CUYAMA BASIN GROUNDWATER SUSTAINABILITY AGENCY STANDING ADVISORY COMMITTEE MEETING

AGENDA

April 25, 2024

Non-Irrigated Fields (preliminary W&C estimate)

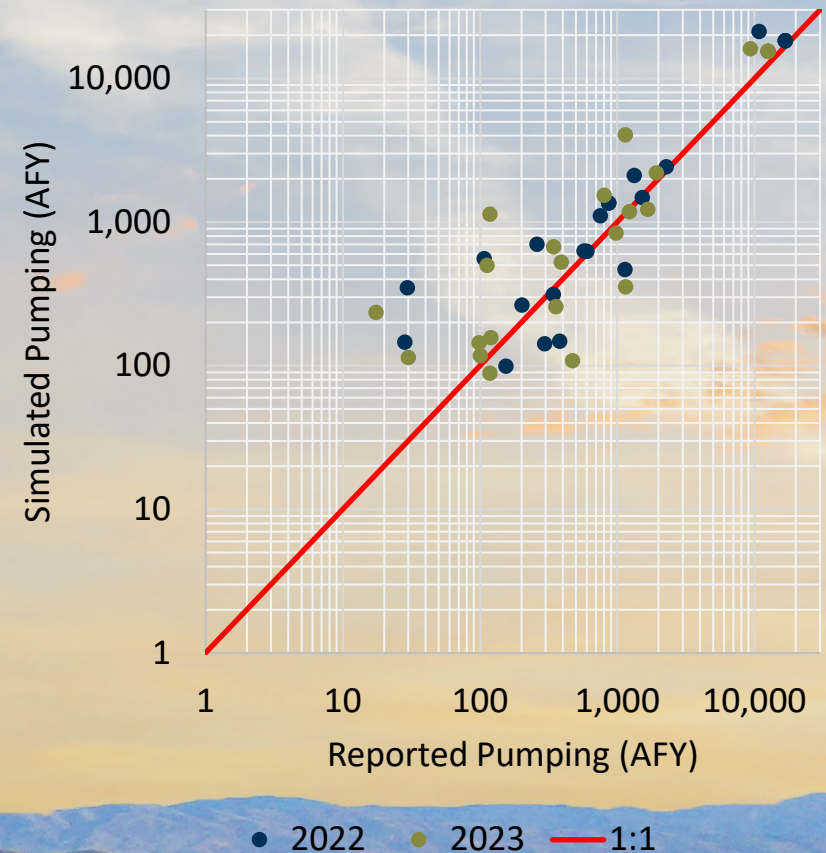
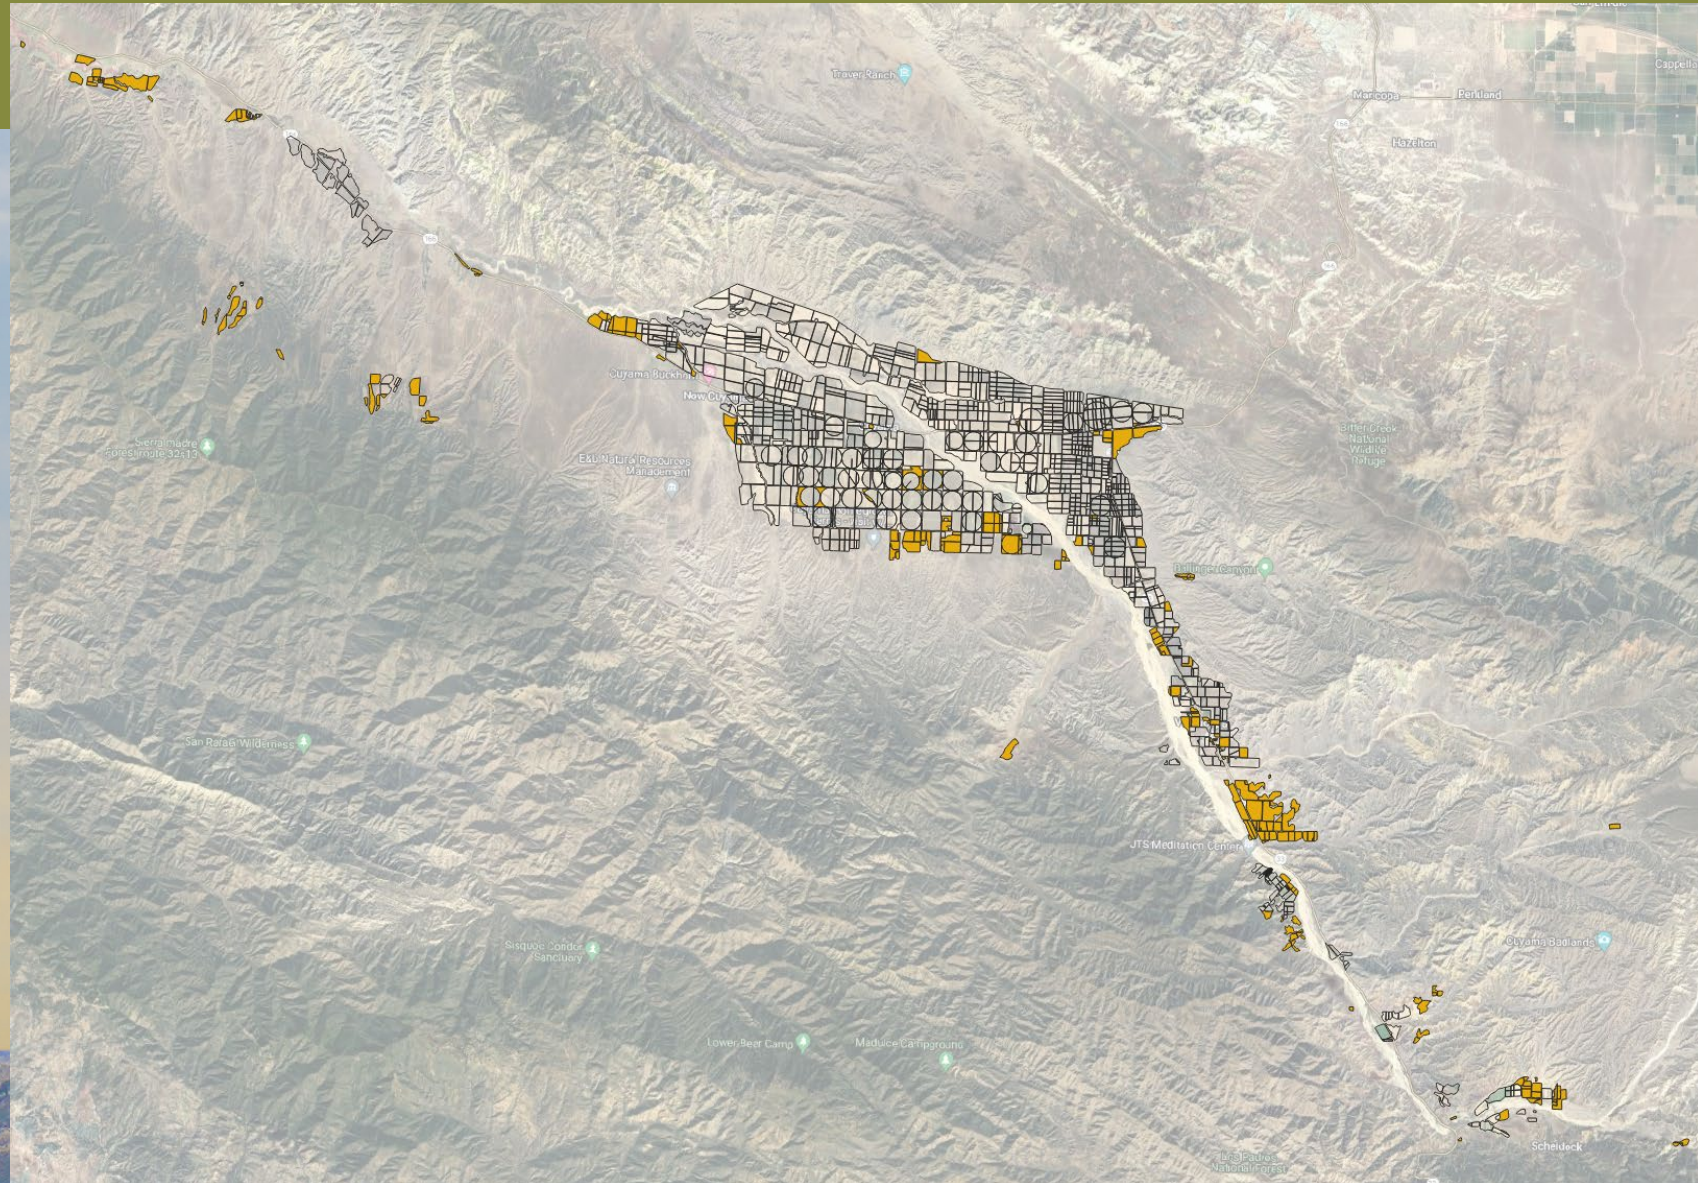
Comment by	Neil Currie, Cleath-Harris (Grapevine Capital)	Jeff Shaw, EKI (Cuyama Basin Water District)
Comment	<ol style="list-style-type: none"> 1. Consider oilfield data 2. Review DeLong surface maps 3. Consider using the AEM data to verify the location of the Rehoboth, Turkey Trap and Graveyard Ridge faults 	<ol style="list-style-type: none"> 1. Recommend presenting calibration error maps 2. Consider adjusting model to a monthly timestep to sync monthly ET demand with actual pumping 3. Ensure old flow meters are not contributing to variance between model and reported pumping
Staff Notes	Will perform these activities	NA
